Subject: Correction to Comment #7 of our 16 February, 2001, letter regarding
the Third Runway Project

Comment 7: The methodology used in performing pseudo-static (seismic) stability analysis is incorrect and may seriously overestimate the ability of the wall to withstand seismic loads.

Figure 1: Hypothetical Seismic Stability Failure Surface

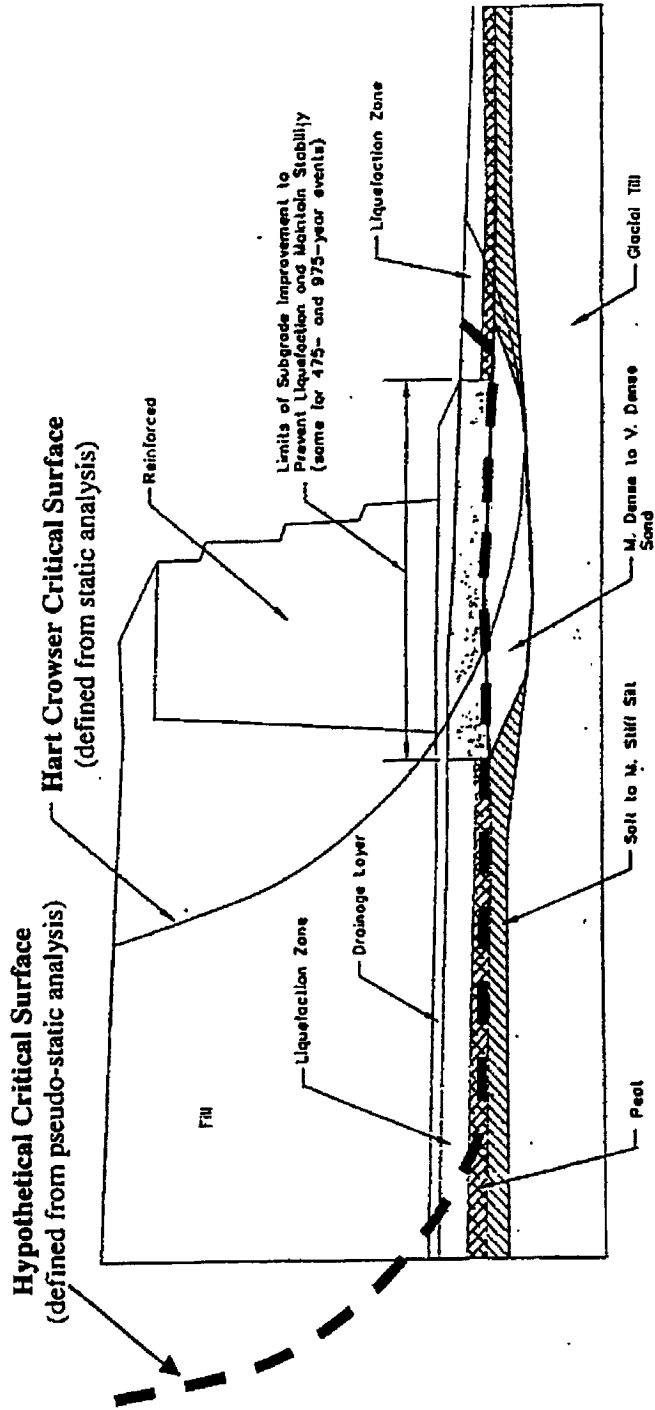
A proper pseudo-static slope stability analysis should be performed to search for the critical failure surface independently of the static analysis. Additionally, "sliding block" failure surfaces that propagate along the weak seams should be examined, rather than just circular surfaces that cut across them. The Slope/W program that Hart Crowser is using is well suited to explore these alternate failure surfaces, and to search carefully for an independent critical pseudo-static failure surface. This analysis will likely result in a reduced factor of safety and may lead to requirements for additional ground improvement.

Figure 1 shows a conceptual sketch of a representative failure surface under pseudo-static conditions, extending through the weak peat layer far back into the fill (and potentially beyond the limits of the modeled cross-section). As currently analyzed and designed only the weak soils directly below the wall are being improved. If the critical seismic failure surface extends along the weak peat layer or liquefied zone farther back into the embankment than the static surface, the areas for ground improvement will also need to extend further back in order to remove the threat of these weak soils under a strong earthquake.
